Rezoning Application: RZ-PD 22-1226

**Hillsborough
County Florida**

REVISED REPORT

APPLICATION NUMBER: PD 22-1226

2.4 Proposed Site Plan (partial provided below for size and orientation purposes. See Section 8.0 for full site plan)

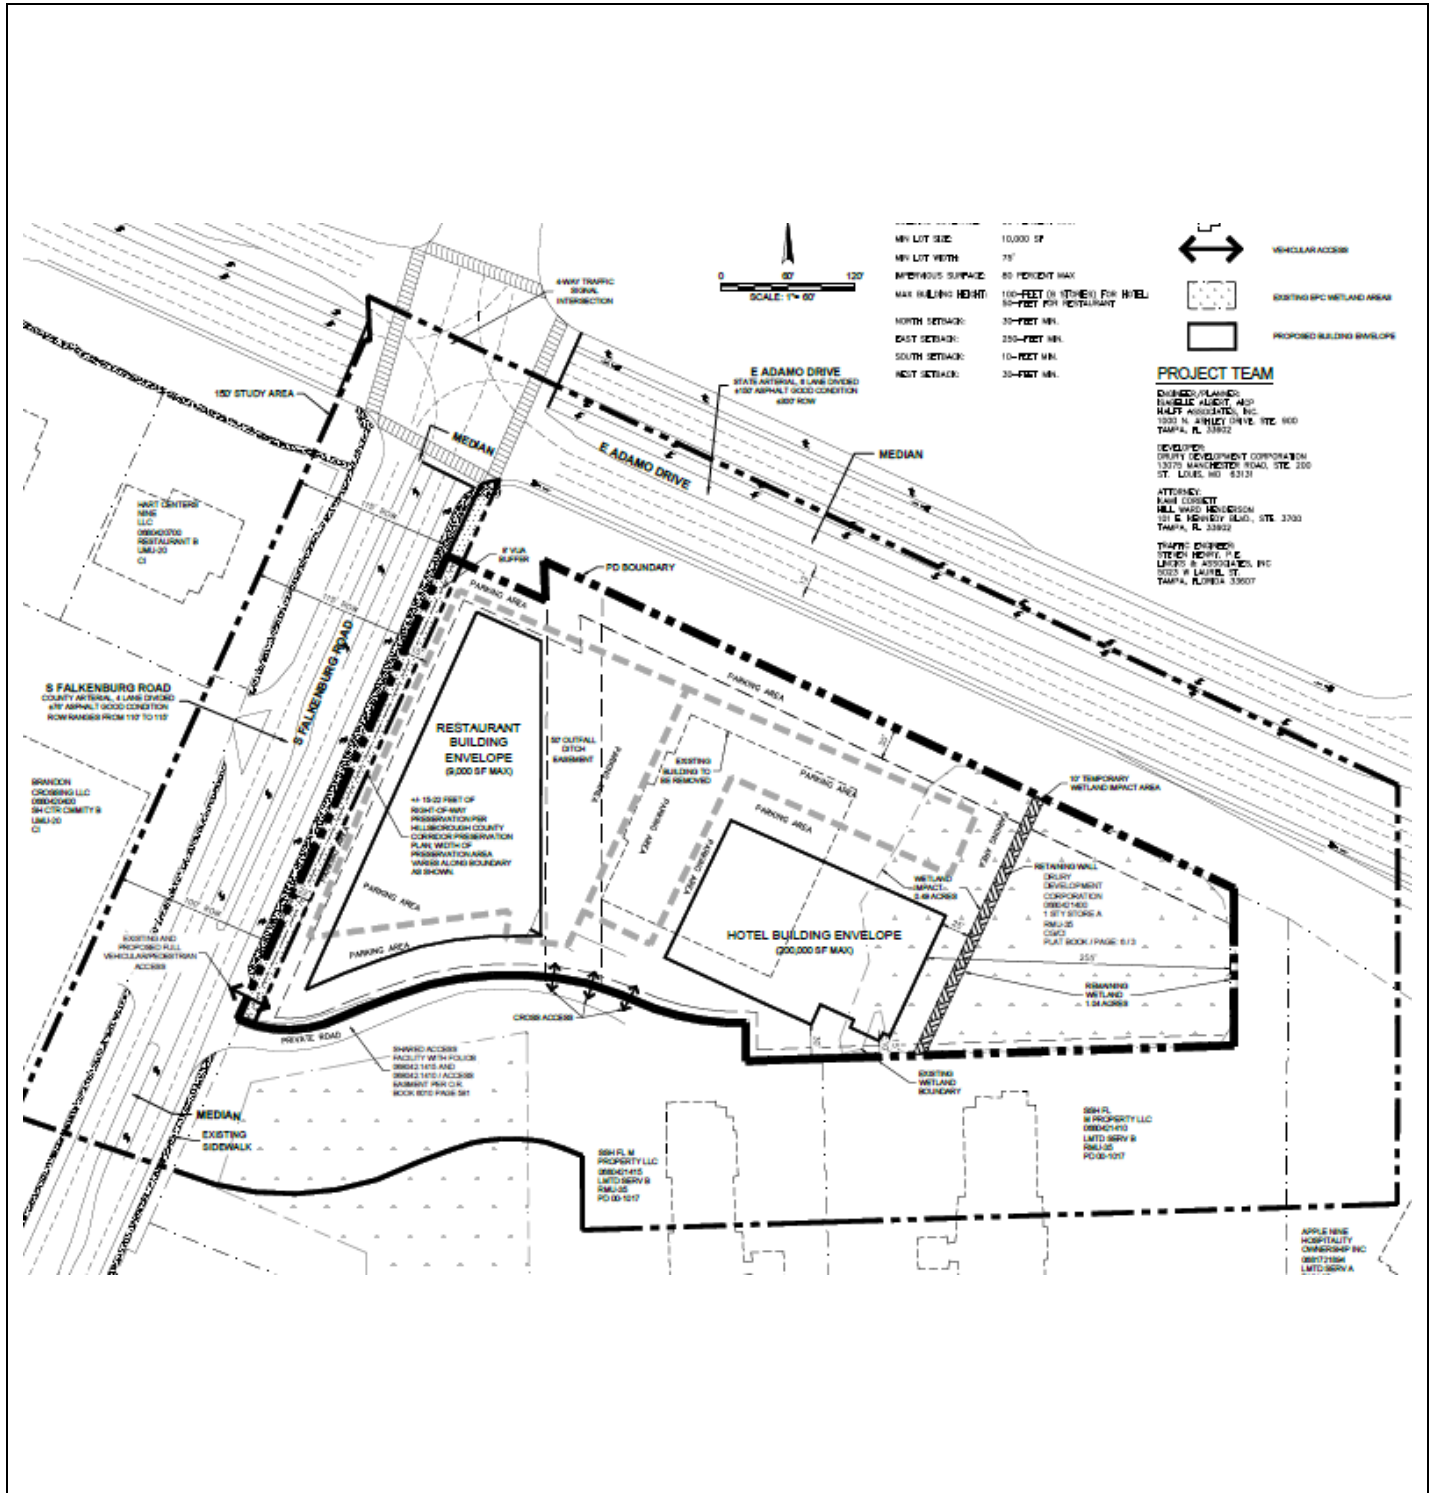
Prior to PD site plan certification, the applicant shall revise the PD site plan to:

- Remove all Cross-access arrows from the site plan.
- Add a note to the site plan that states "Sidewalks to be provided per LDC".

PD PLAN

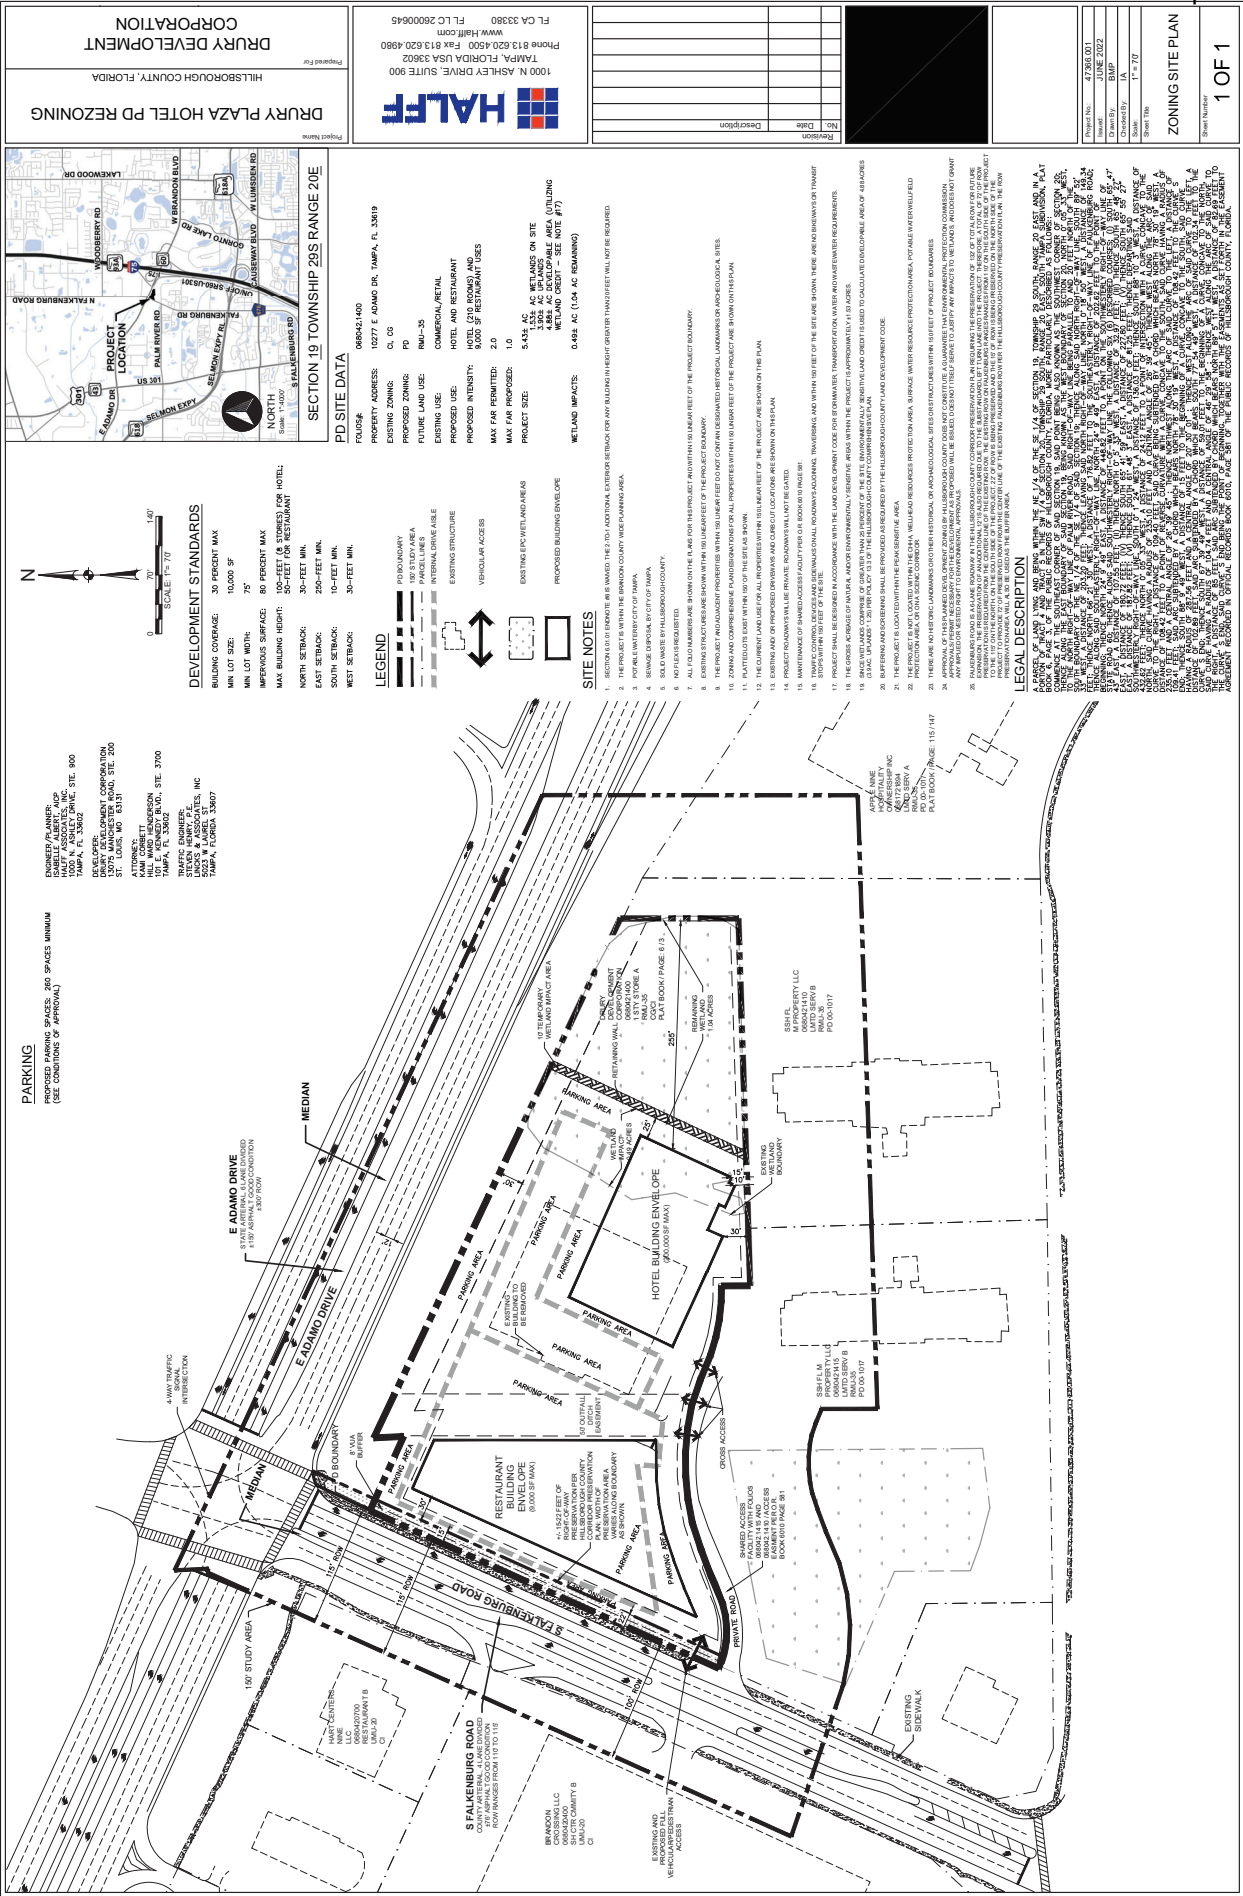
Prior to PD site plan certification, the applicant shall revise the PD site plan to:

- Remove all Cross-access arrows from the site plan.
- Add a note to the site plan that states “Sidewalks to be provided per LDC”.
